APPLICATION NO.	FILING DATE	FIRST NAMED INVENTOR	ATTORNEY DOCKET NO.	CONFIRMATION NO.
09/811,554	03/20/2001	Houng Joong Kim	503.39902X00	3907

Office Action Summary

DETAILED ACTION

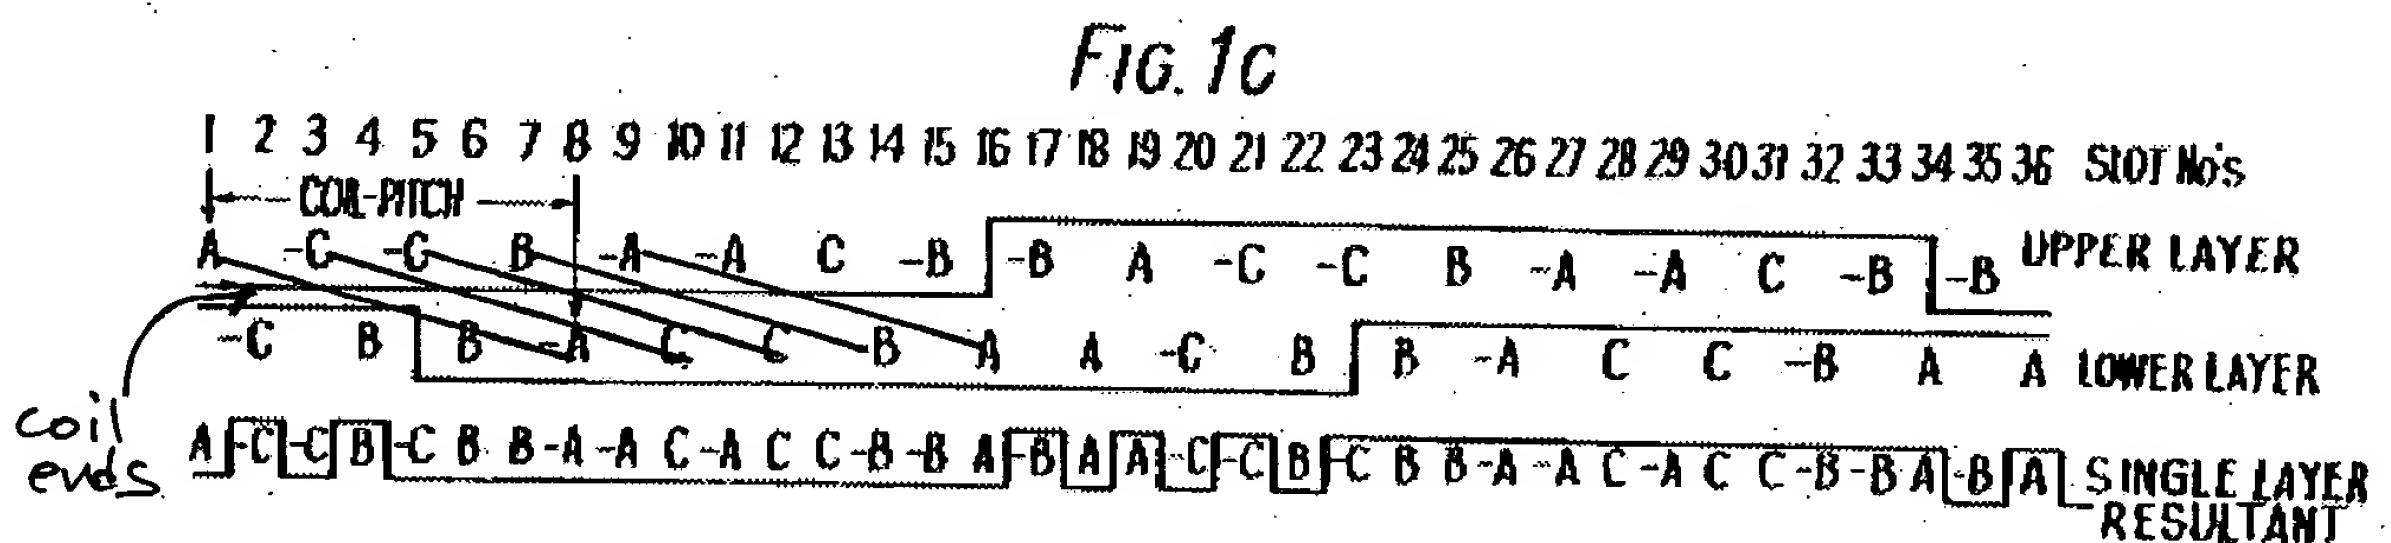
9. Claim 5, as best understood, is rejected under 35 U.S.C. 103(a) as being unpatentable over Broadway in view of Auinger (US 4,127,787). Broadway teaches a "mover," i.e., a rotor, but does not teach a linear motor configuration for the motor, per se.

Auinger teaches three-phase, induction linear motor with windings capable of pole-changing. Further, Auinger teaches that a rotary machine may also be converted to a linear machine (c.18, lines 31-34).

It would have been obvious to one of ordinary skill to modify Broadway and provide a linear motor since, as disclosed by Auinger, rotary machines may be converted to linear machines.

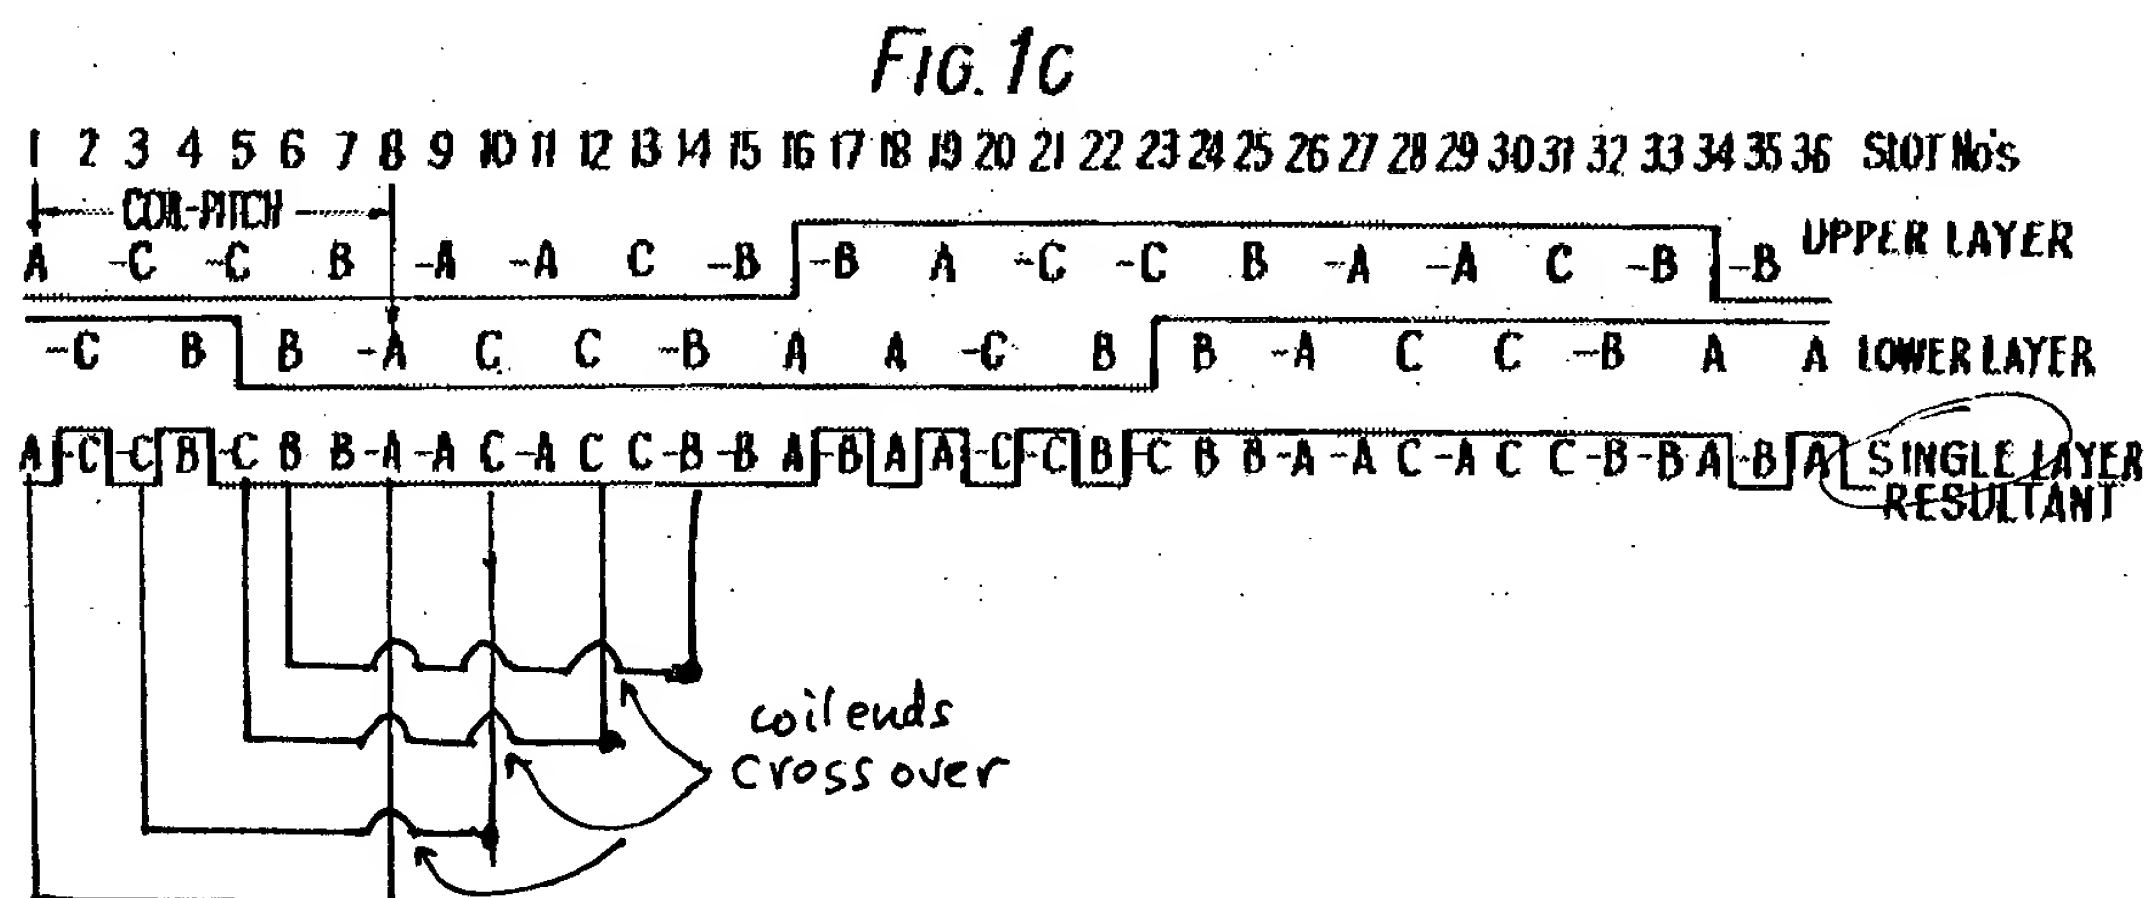
10. Applicant's arguments filed October 15, 2002 have been fully considered but they are not persuasive. Applicant argues that Broadway teaches a winding arrangement similar to that shown in applicant's prior art Fig.10(b), where there is only one phase in each peripheral layer. However, the embodiment of Fig.1C of Broadway shows an arrangement of a three-phase, single layer winding in which the single layer comprises windings of all three phases A-C and which are further arranged so as to satisfy applicant's claimed relationship. Note that the coil pitch is 7, meaning that, for example, the phase coil section A in the "upper" layer in slot 1 travels to the "lower" layer coil (-A) in slot 8. Similarly, coil -C in the upper layer of slot 3 travels to the lower layer of slot 10 (C), and so forth. The end turns connecting the coil sections A/A-, -C/C, -C/C, B/-B, etc. are parallel with one another, slanted at an angle. See Broadway's Fig.1C below.

If the coils were arranged as shown in applicant's Fig. 10(b), as applicant asserts, each coil end would have to cross over another at some point, when viewed along the axial direction; however, this would result in a multi-layer winding. See the modified Fig. 1C of Broadway below. Broadway specifically states that the winding is single layer. Therefore, the Broadway windings do not overlap as applicant suggests.
